Response to Submissions

Project: Additions and Alterations to
Existing Health Services Facility
at President Private Hospital

Client: Macquarie Health Corporation

Date: March 2022

Option A

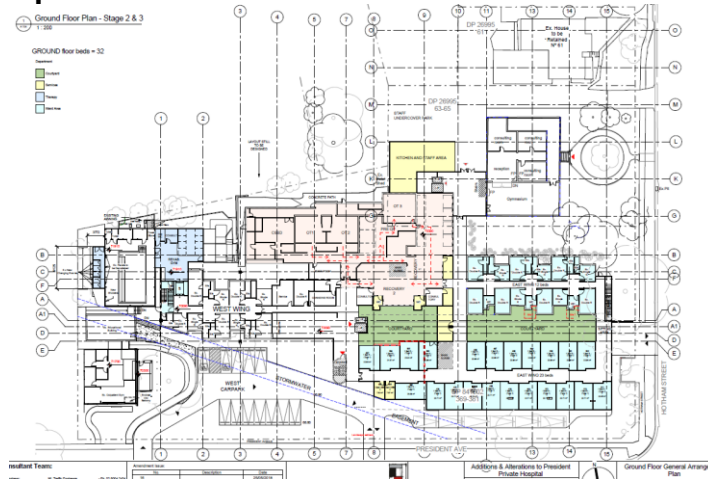
“Hotham House was only recently listed in Sutherland Local Environmental Plan 2015 as a local heritage item and is highly regarded by the local community. Opportunities for the inclusion / retention of Hotham House (i.e. adaptive reuse of the building) in the overall design is to be further investigated and presented demonstrating, through revised schemes, that all options have been considered.”

Option A provides for the partial demolition and adaptive reuse of Hotham House. The rear lean-to section is demolished, and the remainder of Hotham House is left intact. Entry to Hotham House remains from Hotham Rd and the building is not integrated into the Hospital. Separate use of Hotham House was to be determined.

Figure 14: Graphic representation of the proposed light spill study

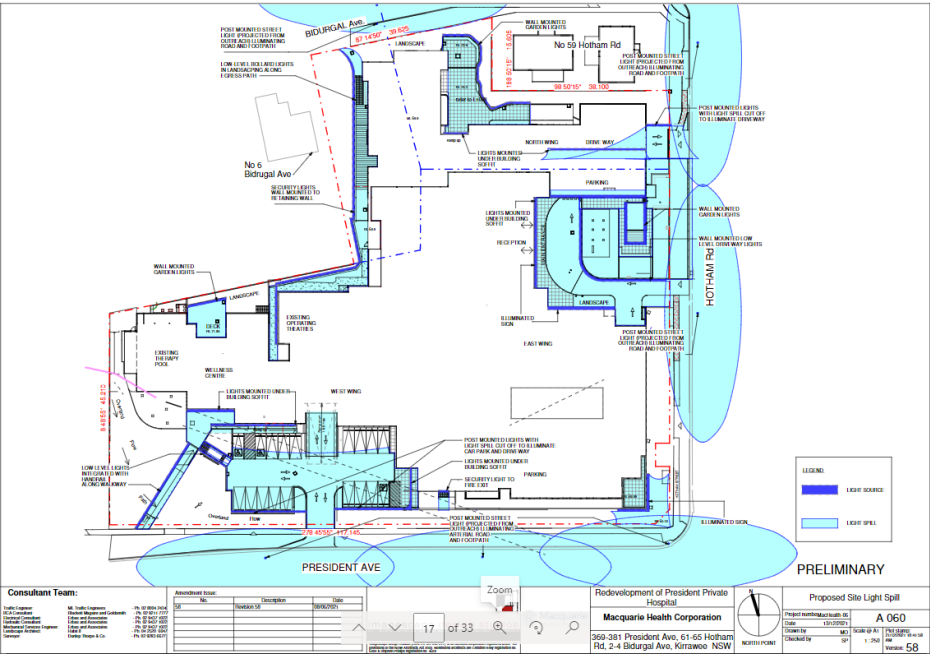
The NSW Department of Planning, Industry and Environment has requested the following matters in relation to Light Spill be addressed:

The style of louvres selected is a trapezoidal configuration made from extruded aluminium and finished in a powdercoat finish. In summary, Louvres have been added to the windows in these elevations to control light spill rather than reliance on trees.

A graphic comparison of external light spill can be seen in drawings A058 Existing Light Spill and drawing A060 proposed Light Spill. Both drawings show the location of the light source and the likely light spill created by the light source. The assessment shows that there is an unlikely change along President Ave and Hotham Road due to the effect of the powerful streetlights already in place. The greatest effective change in light spillage is to the car park off President Ave which has a minimal effect on residents as it is already well light. Also the entry driveways and garden of Hotham Road. A higher level of light spillage is likely in this area to ensure that the way finding for the facility is established. It also tends to be well lit at night to ensure covert security measures can remain in place. Mitigating measures to ensure that lighting levels are not obtrusive to neighbours across Hotham Road will be to:

Figure 15: Evaluation of visual amenity to 59 Hotham Road. Note: POS refers to Public Open Space

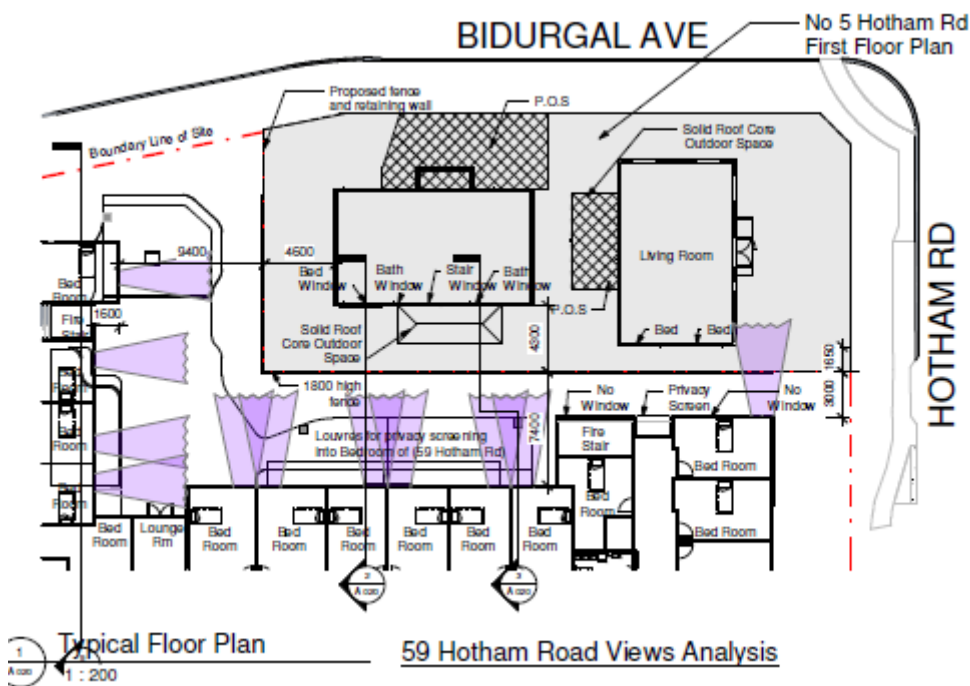
The NSW Department of Planning, Industry and environment has requested the following matters in relation to Privacy be addressed:

As seen in Figure 15, the windows from the bedrooms of the proposal look onto non habitable spaces when facing No. 59 Hotham Road. The compliance set back is 3m, the design has allowed 11.7m. The windows in the development bedrooms facing Hotham Road do face habitable rooms and therefore should be 6m, at the closest point, the bedroom window of the Hospital is setback 14.0m from the building located at No. 59 Hotham Road. None of the windows in the Hospital bedrooms overlook to Private Open Space of either of the units.

Figure 15 shows the relationship of 59 Hotham Road to the northern wing of the hospital. The extent of the viewing cones shown in mauve show the length of 6m which is suggested by objective 3F-1 of the SEPP 65: Apartment Design Guide (July 2015). The design of the hospital complies with this guideline.

The location of the Private Open Space was obtained by the approved Development Application drawings for this site and is shown in a cross hatch in this Figure and shows that none of the windows in the northern wing look directly into the Private Open spaces for either of the units.

Figure 19: Permissible height diagram taken from Sutherland Shire Council DCP 2015

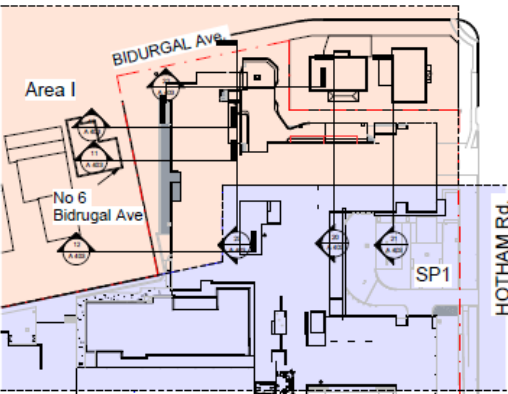
"The section 04 architectural diagram within the architectural plans package appears to demonstrate a height exceeding 15m, whereas the EIS states that the highest point of the proposal within the SP1 zone will be below 15m. in addition, for the proportions of the development which fall into the R2 zone, the height restriction is 5.5m and therefore the proposed building height of 7.5m exceeds this requirement. It is therefore requested that a clause 4.6 variation be prepared justifying the LEP non-compliances.

The proposed site is zoned SP1 and does not have a permissible height as recorded in the Sutherland Shire DCP 2015 and LEP 2015.

No. 61 Hotham Road and Nos. 2 and 4 Bidural Avenue are also included as part of this development. These three (3) sites are zoned Area I on the Building Height Map. The maximum building height in this zone is 8.5m.

Figure 21: Swept paths to President Avenue driveway

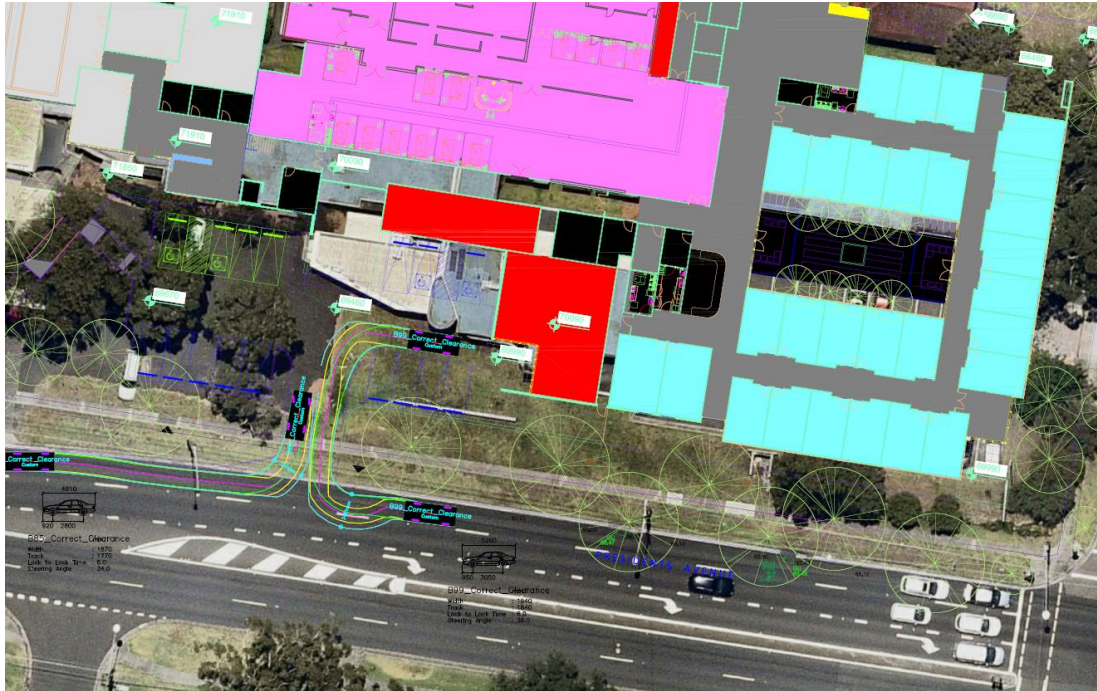
The NSW Department of Planning, Industry and environment has requested the following matters in relation to the additional of a slip lane on President Avenue be addressed:

Due to reverse relationship between the accessing and egressing vehicles during the peak hours, significant conflict between the incoming and outgoing vehicles during the peak hours would be improbable. Hence separation of the entry and exit driveways is deemed unnecessary. The swept path of a B85 and a B99

passing each other at the proposed driveway has been checked to ensure sufficient clearance between entering and existing vehicles at the same time. Swept path diagram and associated manoeuvres are provided and show no conflicts.

Figure 22: showing the wider driveway access to President Ave.

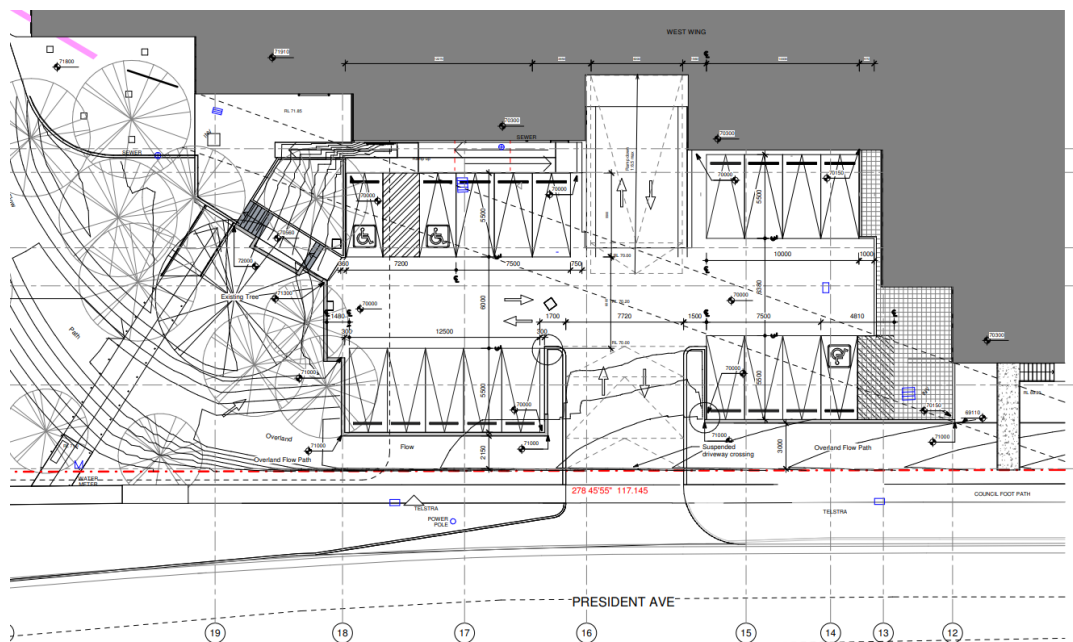
The DPIE has carried out a peer review produced by TTPP. In relation to access to President Ave they say *“Vehicle access from an arterial road has not been fully considered and has not addressed Council’s safety concerns.”*

In consideration of Sutherland Shire Council's concern regarding the President Ave driveway the design team worked with ML Traffic to provide a wider entry driveway to facilitate turning in and out of the kerbside lane only. Refer dwg A028 for revised arrangement. This wider driveway has been achieved without impacting on the landscape design.

Figure 24: The end of trip facility for bicycle parking is located in the Basement Level 2

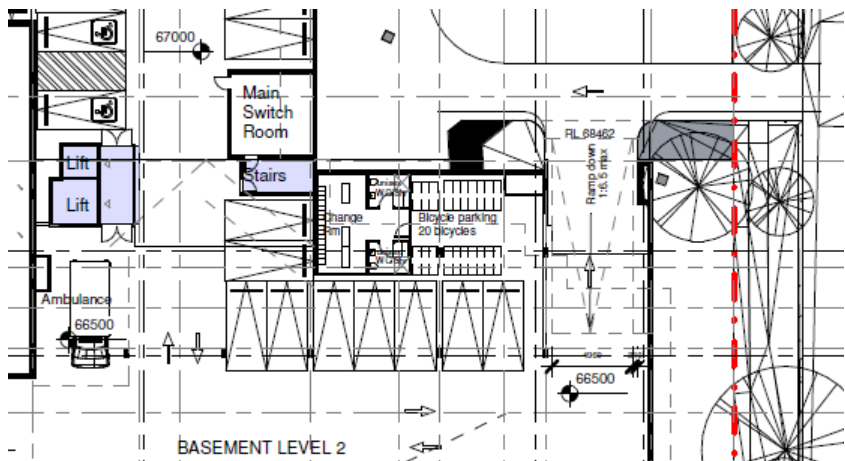
"The Traffic and Parking Assessment (TPIA) provided as part of the proposed development does not address TfNSW policies for integrating transport with landuse, or the requirements of the Sutherland Shire Development Control Plan (DCP) 2015 regarding off-street bicycle parking and end of trip facilities. The application is to be amended including the TPIA to satisfy the minimum requirements of the Sutherland Shire DCP 2015 in regard to the provision of adequate and suitably located secure end of trip facilities and off-street bicycle parking in accordance with Australian Standard 2890.3"

The bicycle parking and end of trip facilities is located on basement level 2 (Refer drawing A 103).

The facility has parking accommodation for 20 bicycles, 2 unisex toilets including showers and a locker and change area. The room will utilise sensor lights to ensure user safety and CCTV to the entry / exit point will further address user safety. The access and usage of the end of trip facility is located well away from access paths used by pedestrians, private vehicles, and service delivery vehicles.

Figure 27: Location of easement

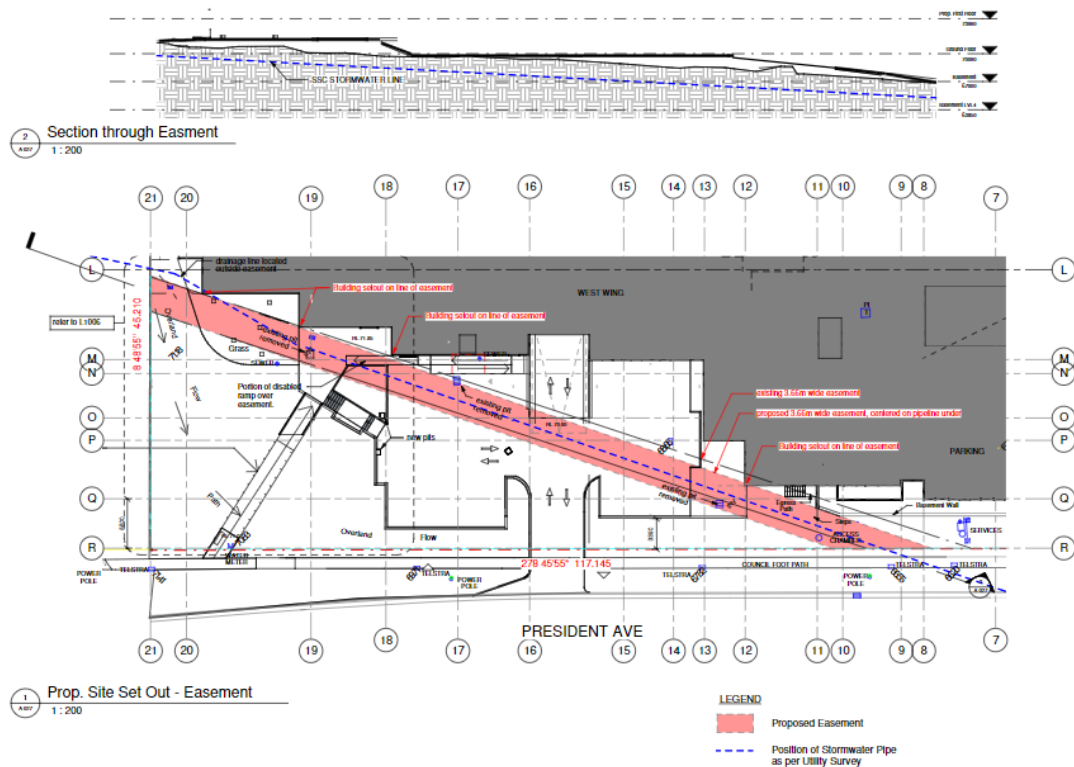
“Please show the proposed alignment of the realigned easement with respect to proposed and existing infrastructure.”
